# CITY OF ALBUQUERQUE

**Re: Bombs Away Beer Co.**  
**9801 Acoma Rd SE**  
**Traffic Circulation Layout**  
Architect's Stamp XX-XX-XX (L20-D070)

Based upon the information provided in your submittal received 11-29-16, the above referenced plan cannot be approved for Building Permit until the following comments are addressed:

SITE PLAN / PARKING

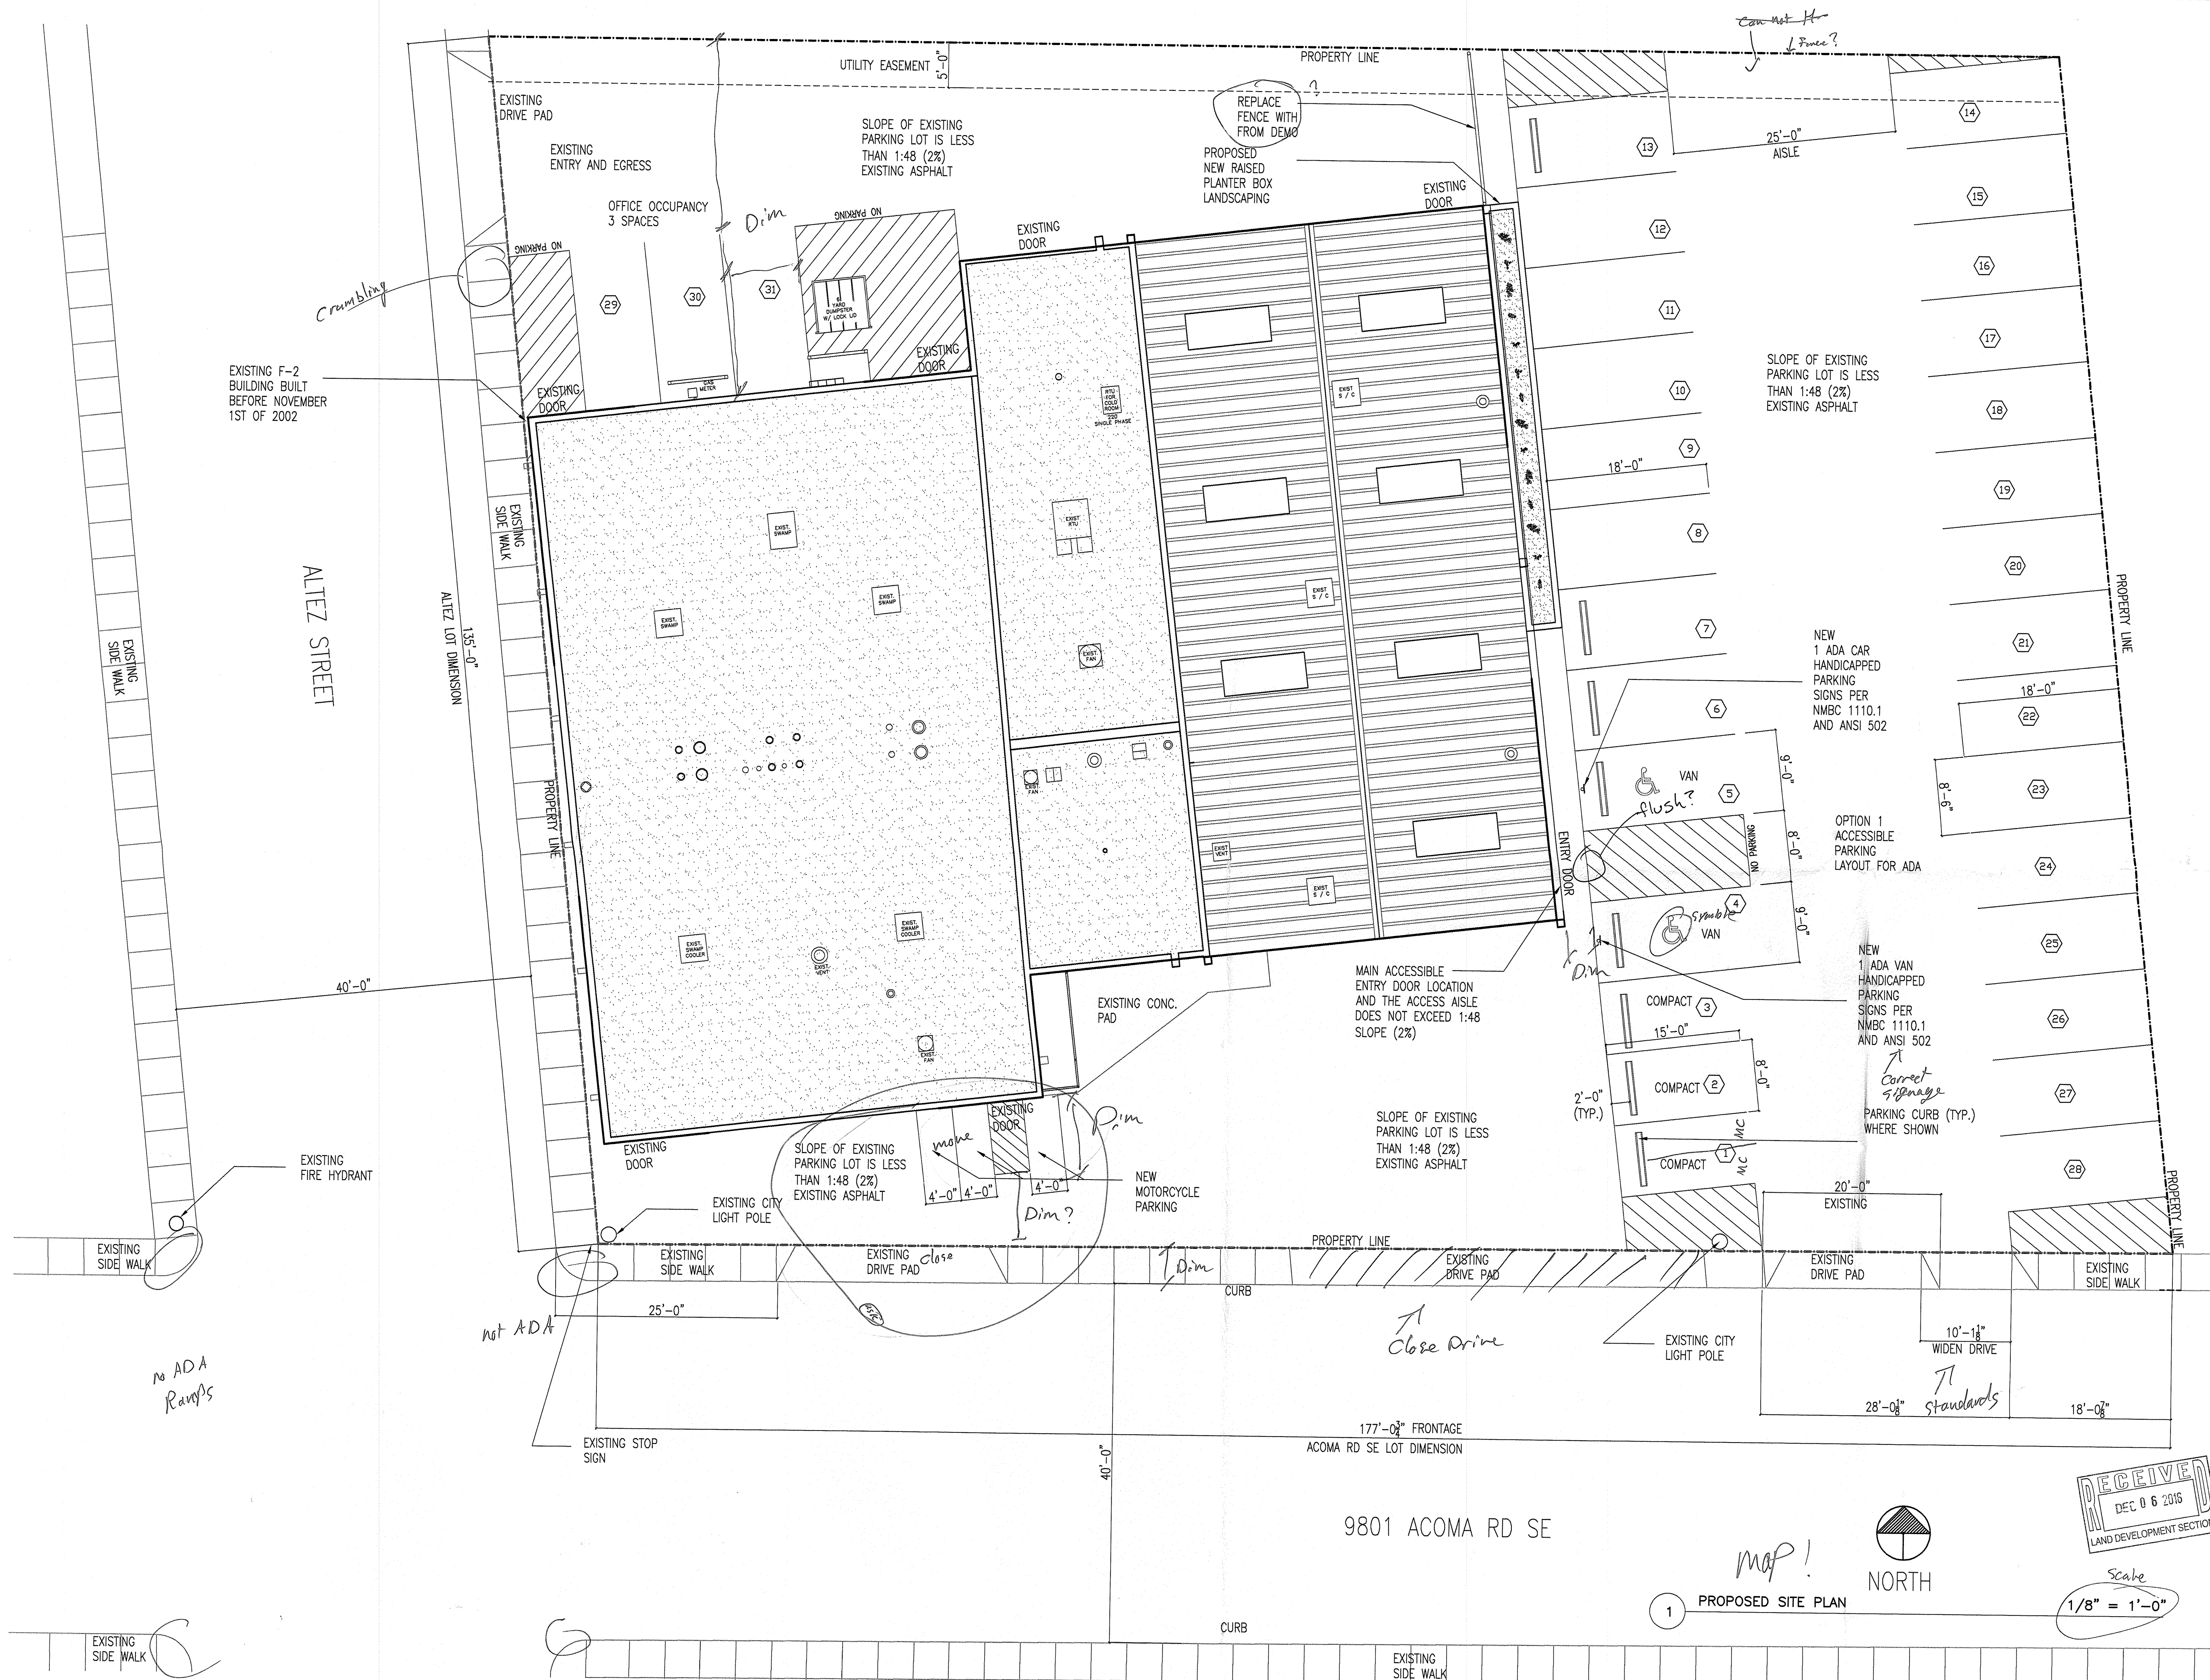
1. Please show a vicinity map showing the location of the development in relation to streets and well known landmarks.
2. A scale of 1"=20' is recommended for sites less than 5 acres per the Development Process Manual, Chapter 27, Section 2, Part B.1.

3. The traffic circulation layout must be stamped, signed, and dated by an engineer or architect licensed in the state of New Mexico.
4. Please identify all existing drive pad widths.

5. Please list the width and length for all existing and proposed parking spaces. Some dimensions are not shown. What are the dimensions of the parking stall in the back?

6. Label the compact parking spaces by placing the words "**COMPACT**" on the pavement of each space.
7. The ADA accessible parking sign must have the required language per 66-7-352.4C NMSA 1978 "**Violators Are Subject to a Fine and/or Towing.**" Please call out detail and location of HC signs.

8. The ADA parking space has a clearly visible, blue, International Symbol of Accessibility painted on the pavement at rear of the space (66-1-4.1.E NMSA 1978) or MUTCD recommends a white symbol on a blue background.

9. Show all drive aisle widths and radii. Some dimensions are not shown. Please dimension the distance from the parking stalls in the back to the end of the drive aisle, also dimension the aisle for the motorcycle parking.

10. Per the zoning code, a 6 ft. wide ADA accessible pedestrian pathway is required from the public sidewalk to the building entrances. Please clearly show this pathway and provide details or notes if it is flush with the entrance.

11. Per DPM, a 6 ft. wide ADA accessible pedestrian pathway is required from the HC parking stall access aisles to the building entrances. Please clearly show this pathway and provide details.
12. Please specify the City Standard Drawing Number when applicable.
13. Unused curb cuts must be replaced with sidewalk and curb & gutter. A build note must be provided referring to the appropriate City Standard drawing.
14. The second driveway on Acoma Rd must be closed. Please relocate the motorcycle and close the NW driveway on Acoma RD.
15. Add a note stating "All broken or cracked sidewalk must be replaced with sidewalk and curb & gutter." A build note must be provided referring to the appropriate City Standard drawing.
